PLANNING COMMISSION MEETING

Project Name: Sunset Cove
 Description: Preliminary site plan & special land use approvals
 Date on Agenda this packet pertains to: March 2nd, 2023

RE: Sunset Cove Condominiums- Preliminary Site Plan Review – 2nd Review

RE: Sunset Cove
Preliminary Site Plan and Special Land Use – Review #2

SHEET
5

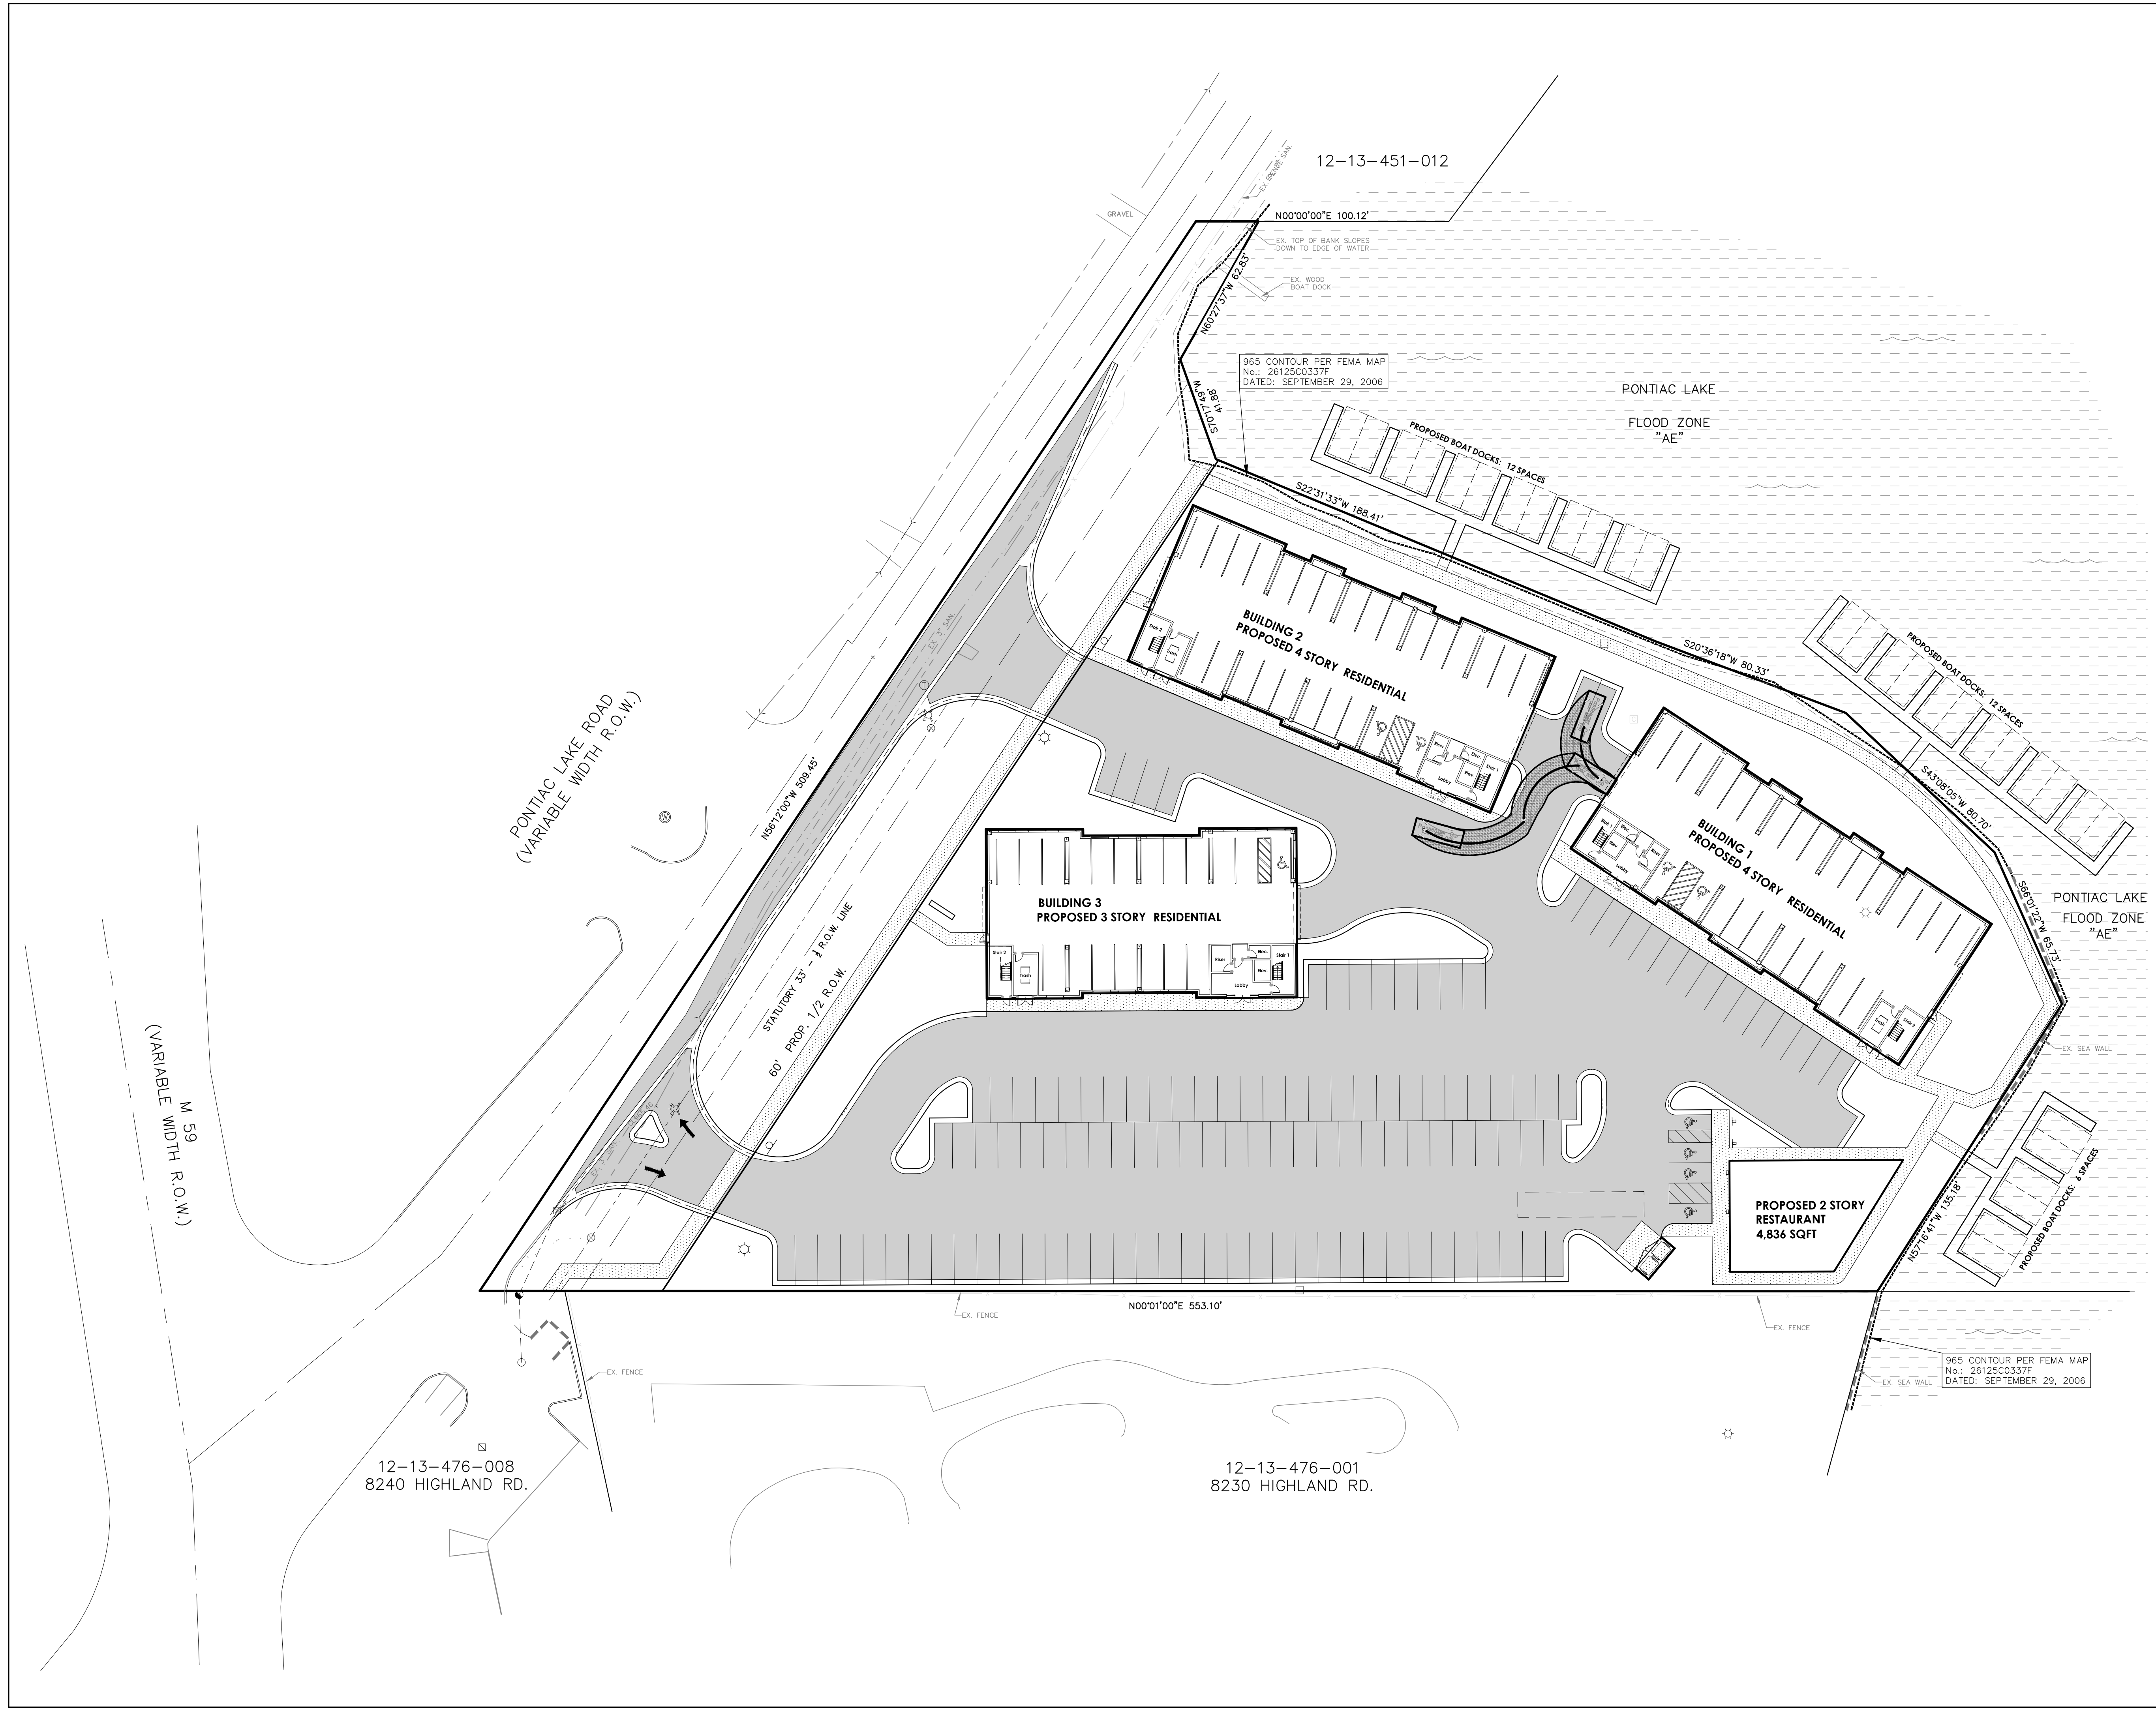
- i) *We defer to the Township Fire Department regarding hydrant spacing/coverage.* **Comment remains as a notation.**
- j) *Provide fire truck turning plan to demonstrate adequate turning radii for fire trucks.* **Comment addressed. A turning plan has been provided.**

sheet no.
L-1

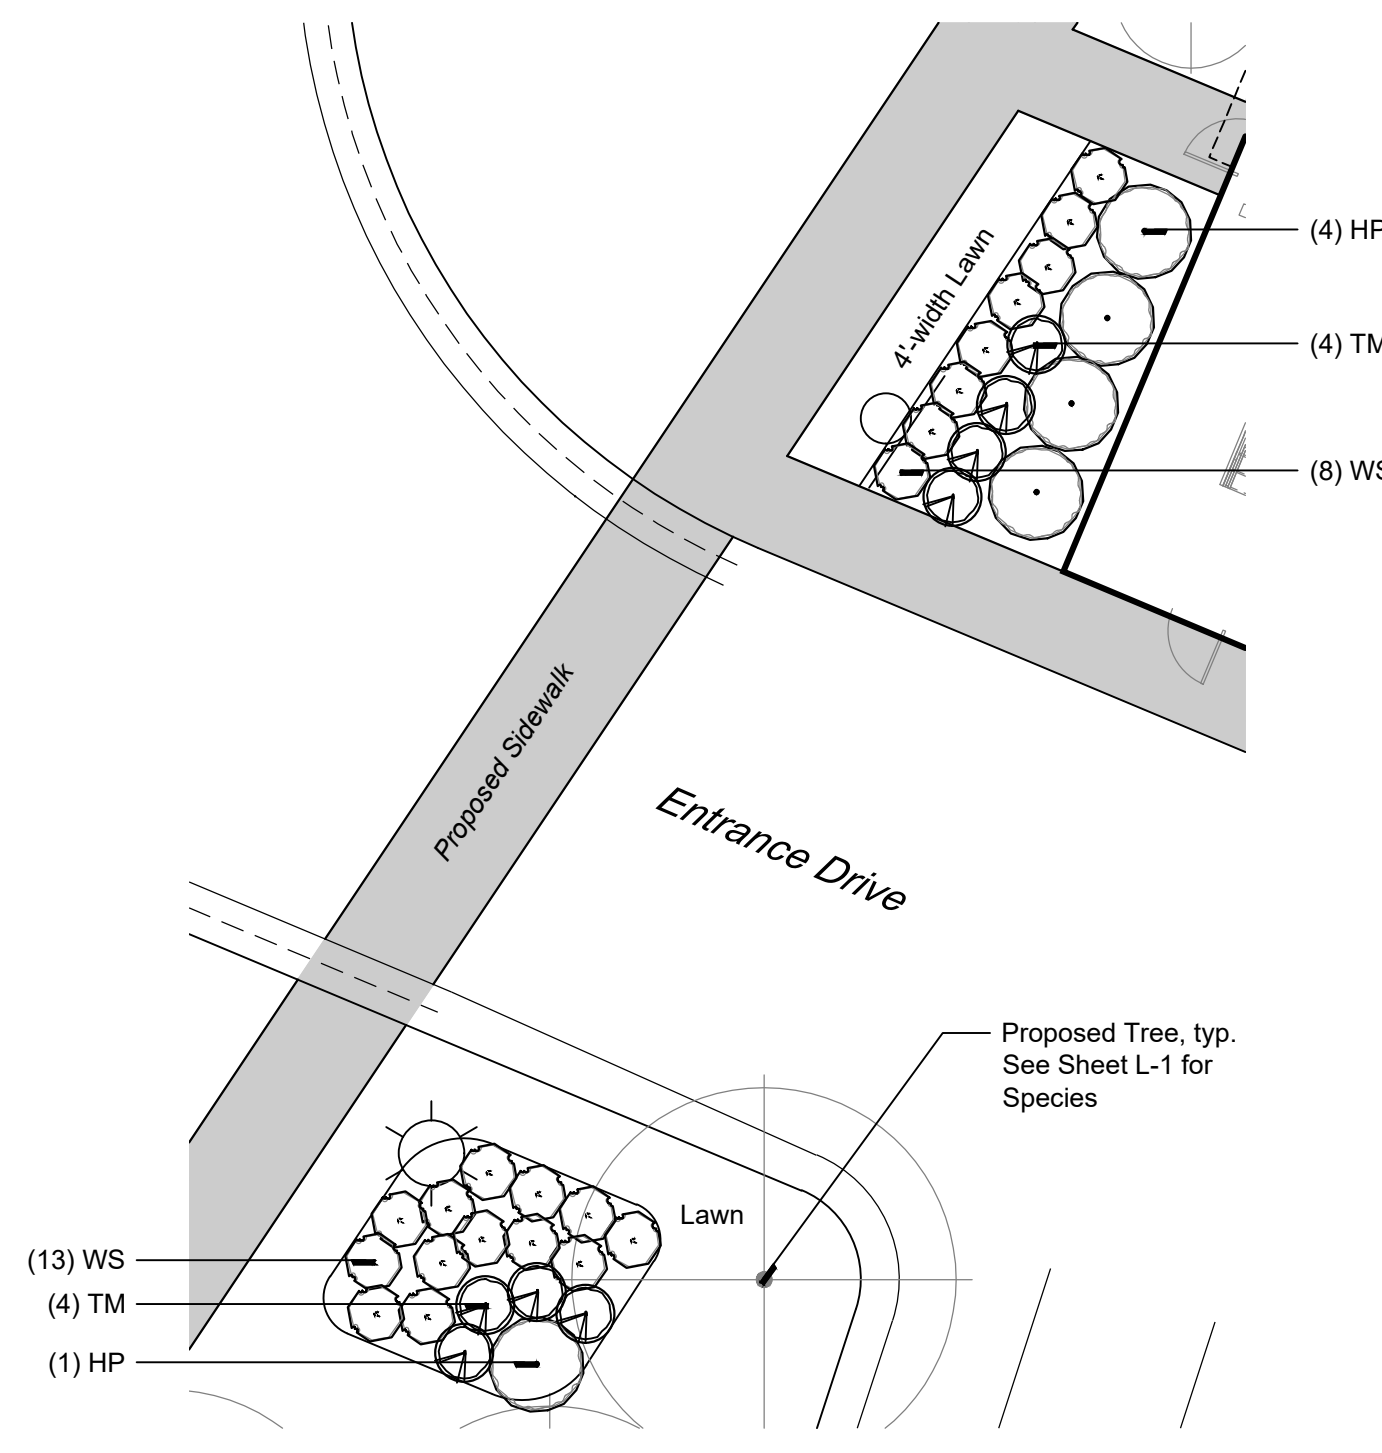
- **A 20-foot greenbelt with one large deciduous or evergreen tree and eight shrubs for every 30 linear feet is required for circulation drives, parking lots, and delivery/service areas adjacent to the Pontiac Lake Road right-of-way. An approximately 16-foot variance from the Zoning Board of Appeals is required based on the proposed parking setback. Furthermore, with lack of land area to maintain landscaping, the required greenbelt plant material likely cannot be provided, requiring an additional variance.** (Comment rescinded. A variance is not required as circulation drives and parking stalls are now at least 20 feet from the Pontiac Lake Road right-of-way).
